Town of Surfside

Abbott Avenue Stormwater Improvements Project

Addendum No. 6

Date Issued: April 11, 2023

SHEET NUMBER **CP-401**
PROJECT NUMBER **11494.01**

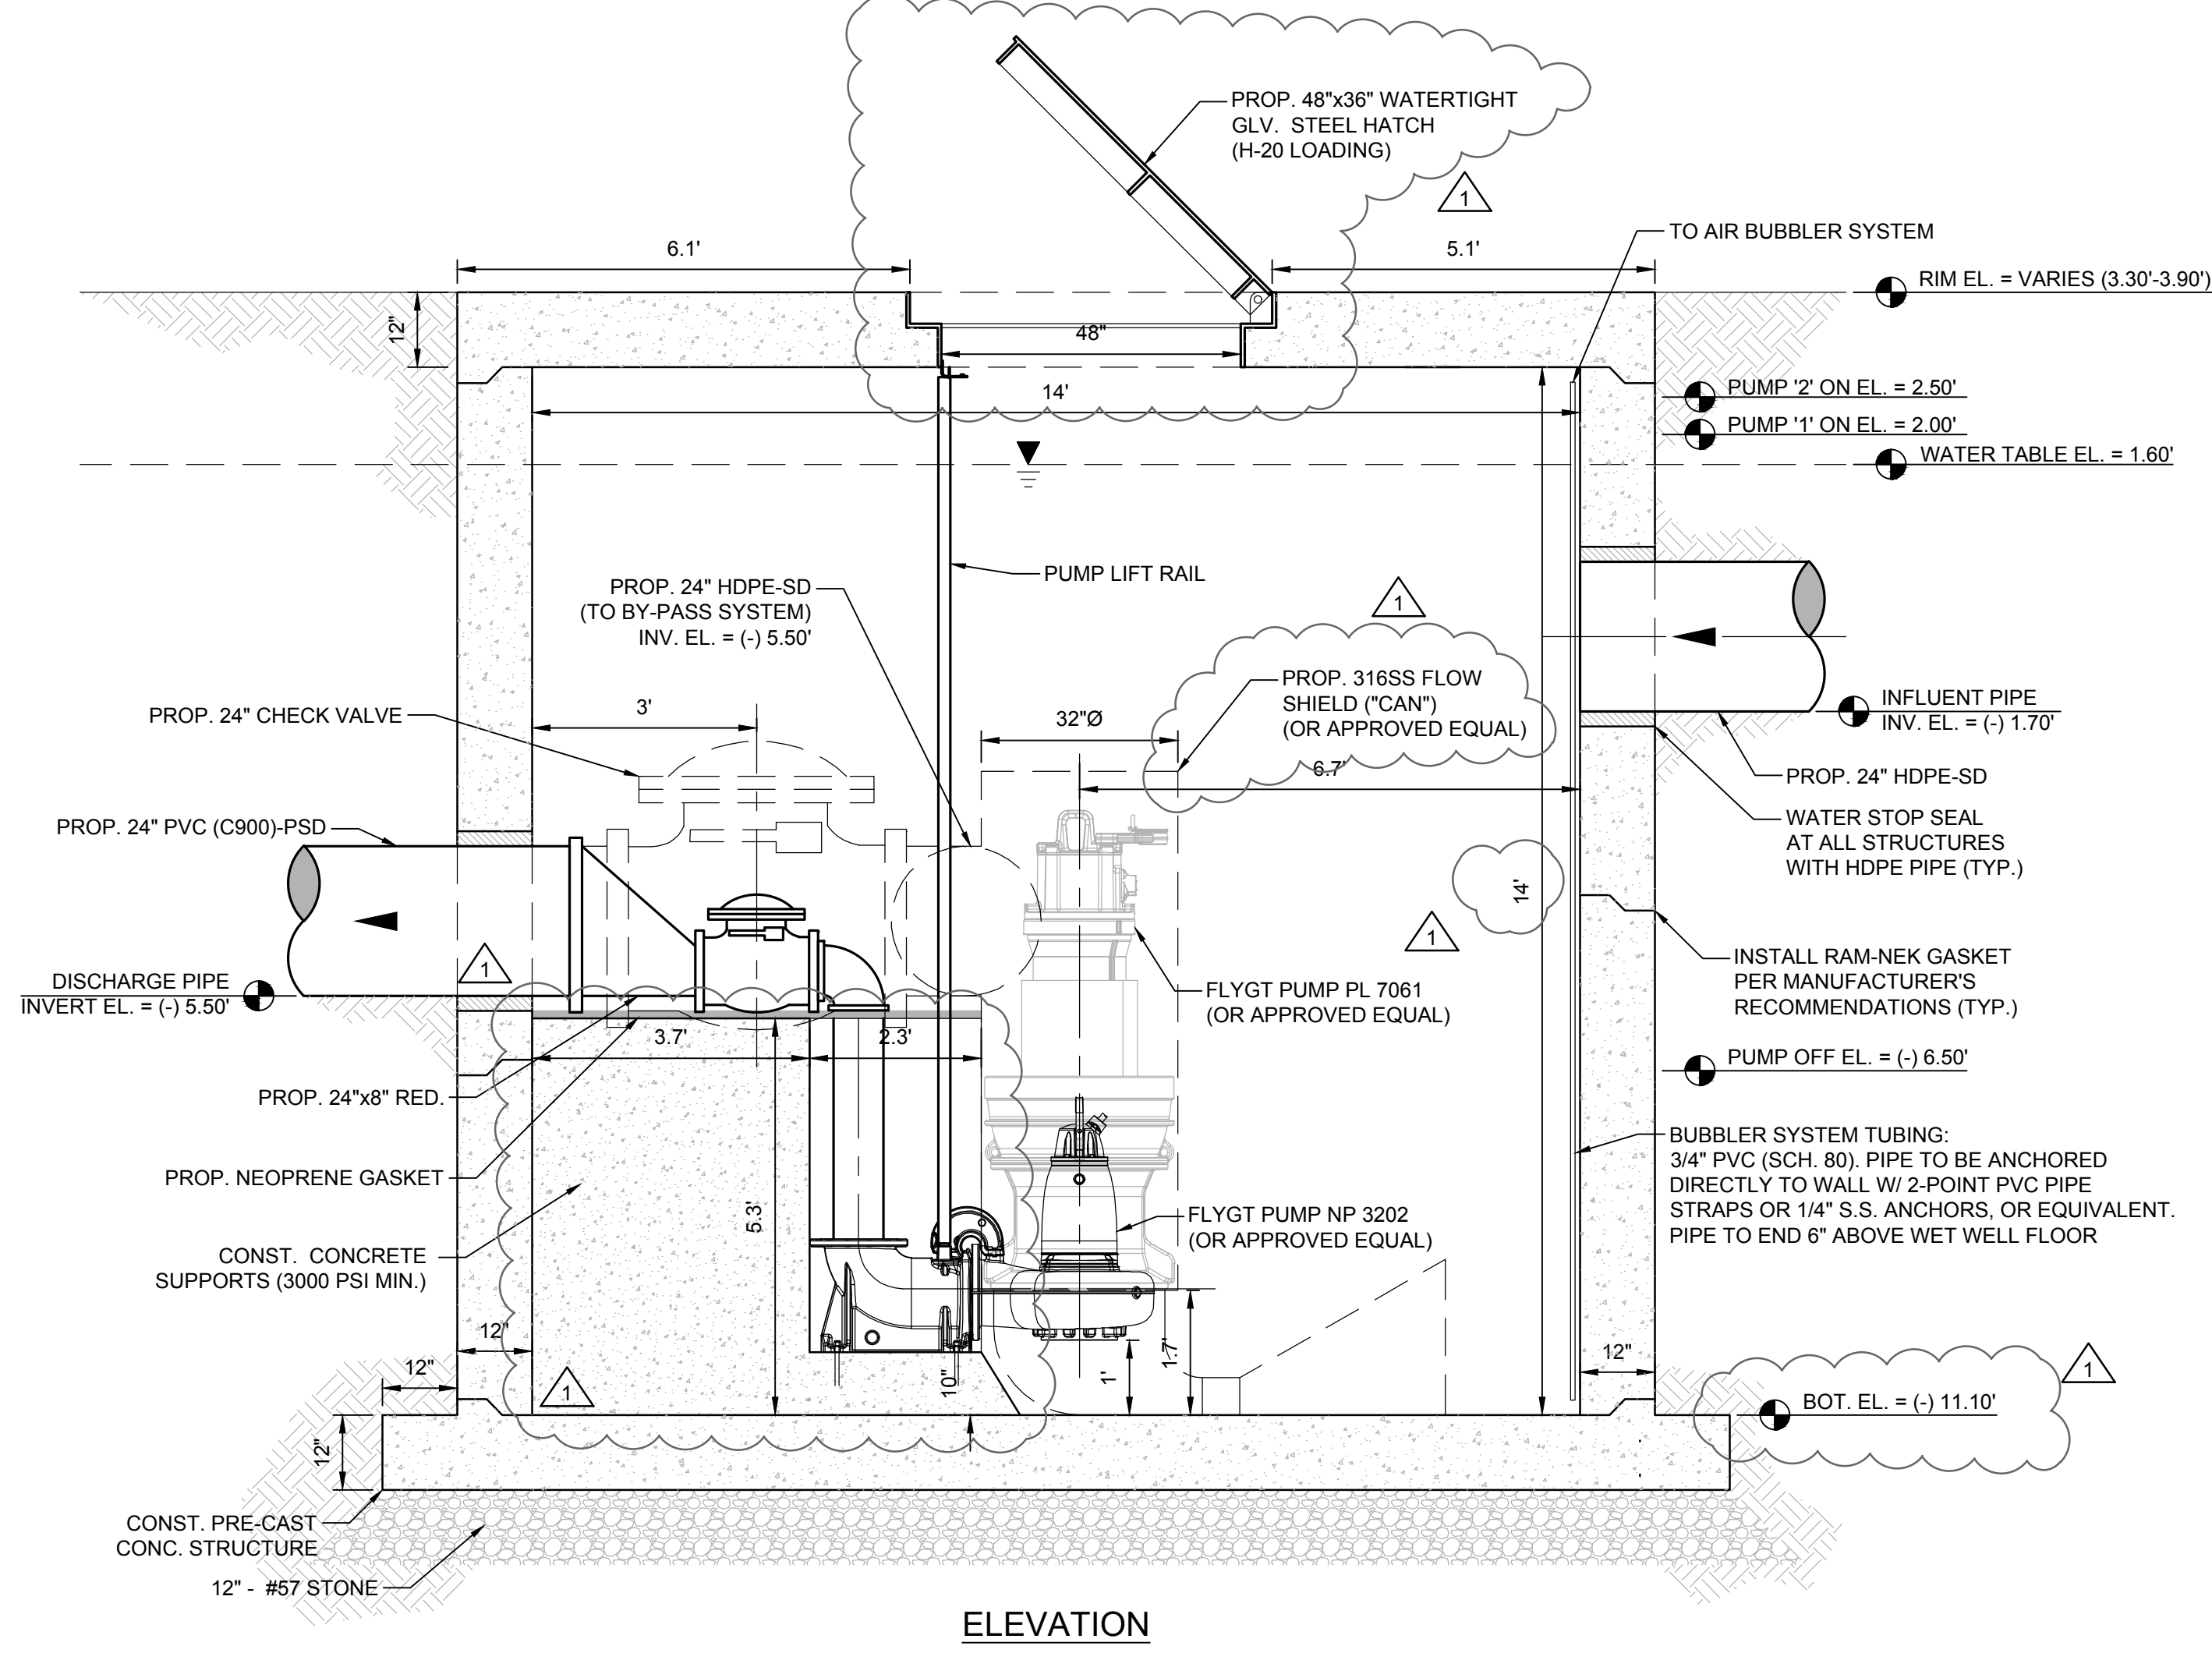
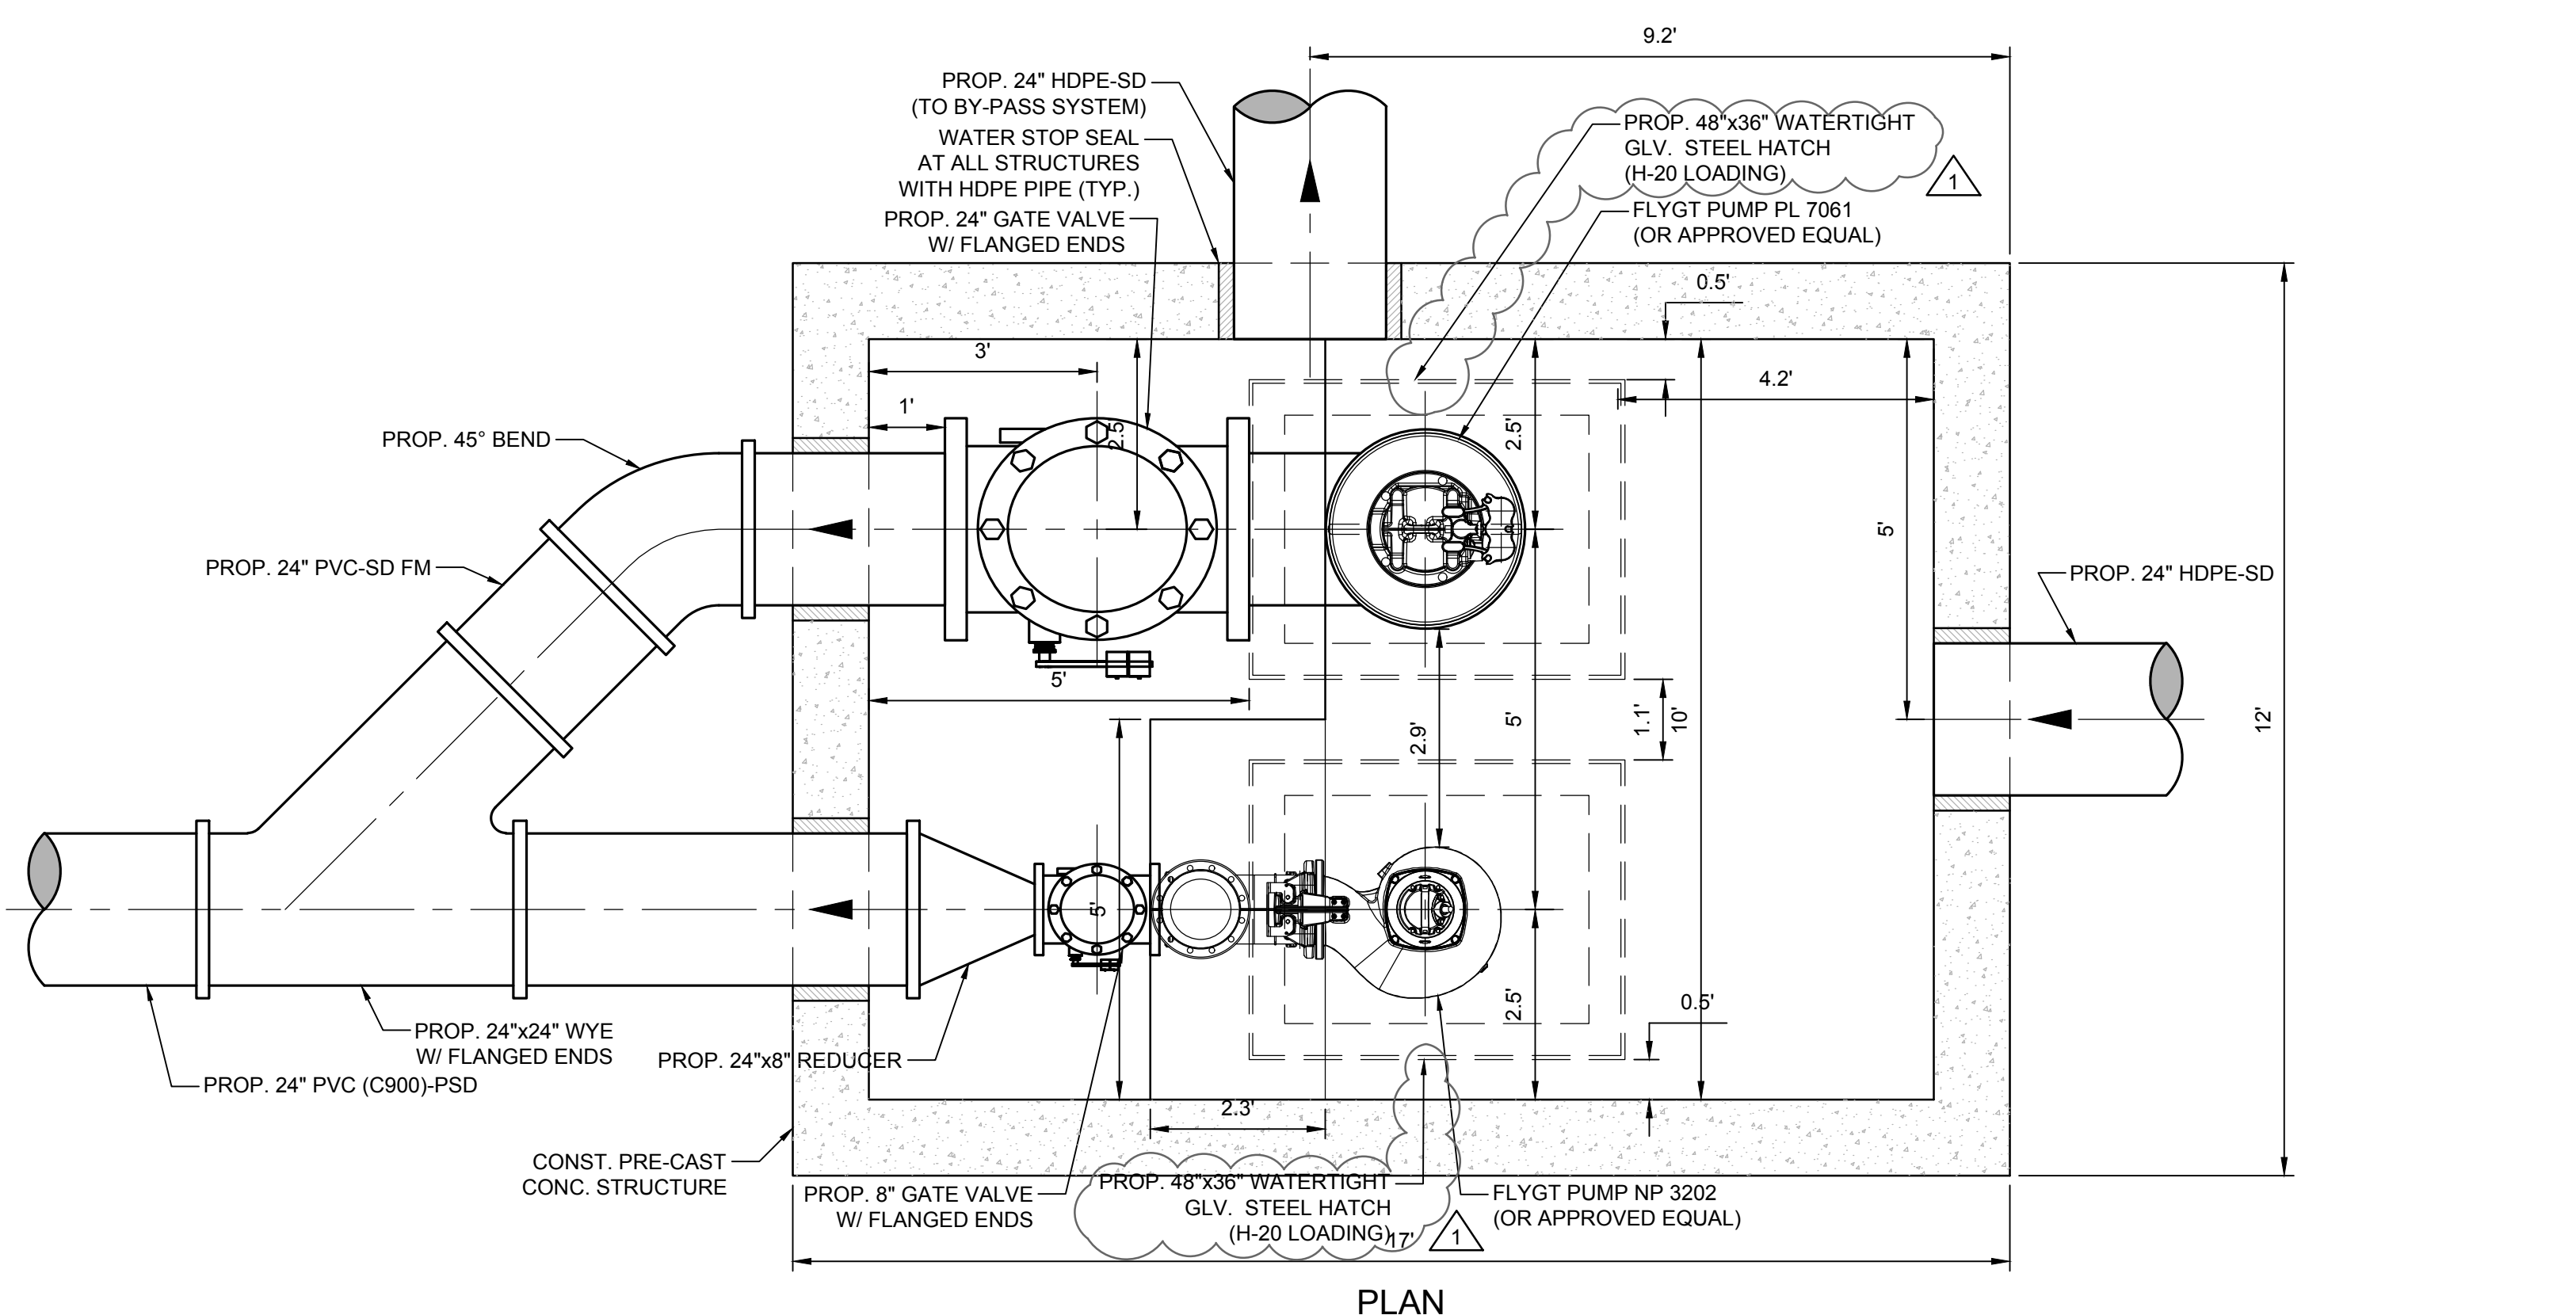
- 7. The pump station Secondary pump would be supplied in a "Pump Can", there's no mention of what material? Being storm water, I would like to assume 316SS to keep the can structure from rotting. The pump details listed on sheet CP-408 do not show the pump can that the pump operates in. I have also attached sheet CP-404 in which I circled the part I am talking about the "Can". Lastly, I have attached a recent submittal sample only can drawing. This is a pretty important piece for longevity of the equipment.**

- 8. Update to Response Relating to Previously Answered Question: Regarding the sets of plans received, we went over them and found the design plans for Pump Station #1, yet the project indicates there will be a second pump stations. Could you please advise if these plans are forthcoming?**

Response: As suggested, the "pump can" can be 316 SS (or approved equivalent) to prevent rotting. The pump station profile on Sheet CP-401 and CP-404 has been updated to better fit the proposed pump can. Refer to the latest plan sheets with Delta #1 revision.

Response: ITB Plan Set includes Sheets CP-401 and CP-404, which include the plan and profiles for both pump stations. Please note sheets CP-401 and CP-404 have been updated and are hereto attached.
